TPS2590 Start up characteristic

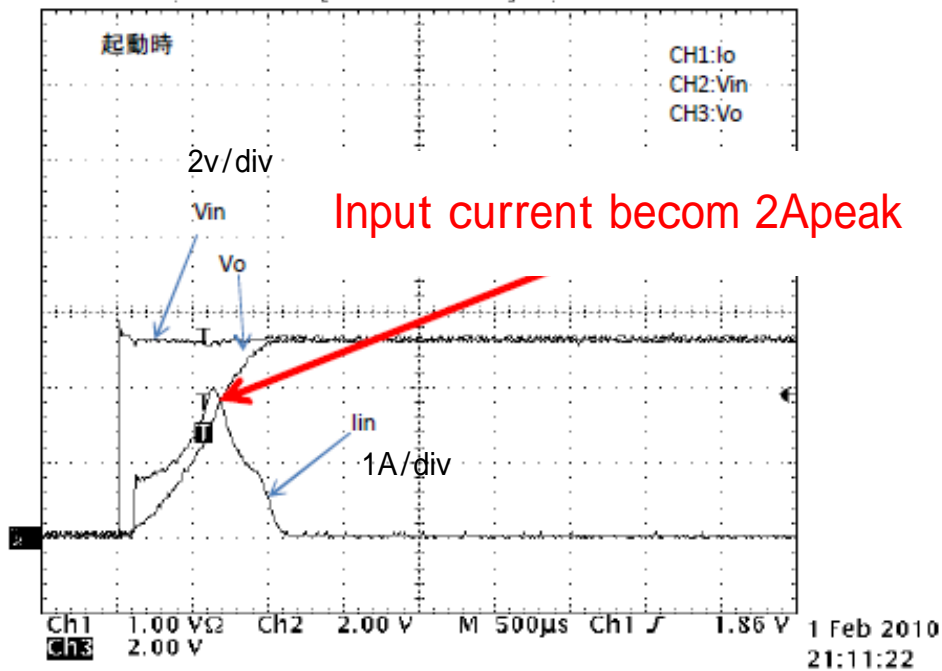
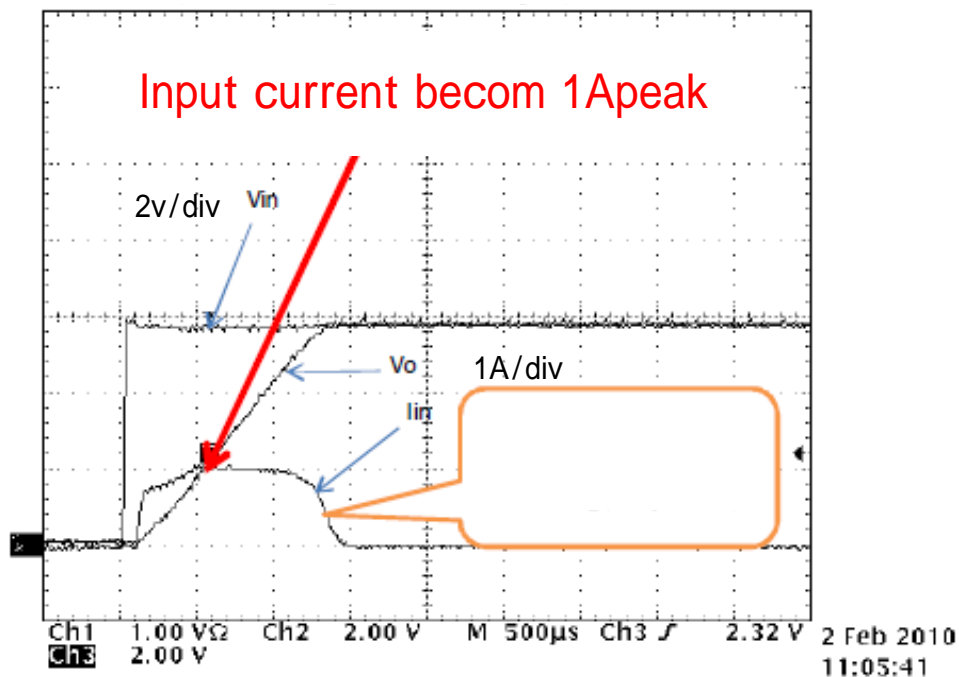
When ILIM and an IFLT level were changed, the peak value and waveform of the input electric current changed. Why do you change? Please teach the mechanism.
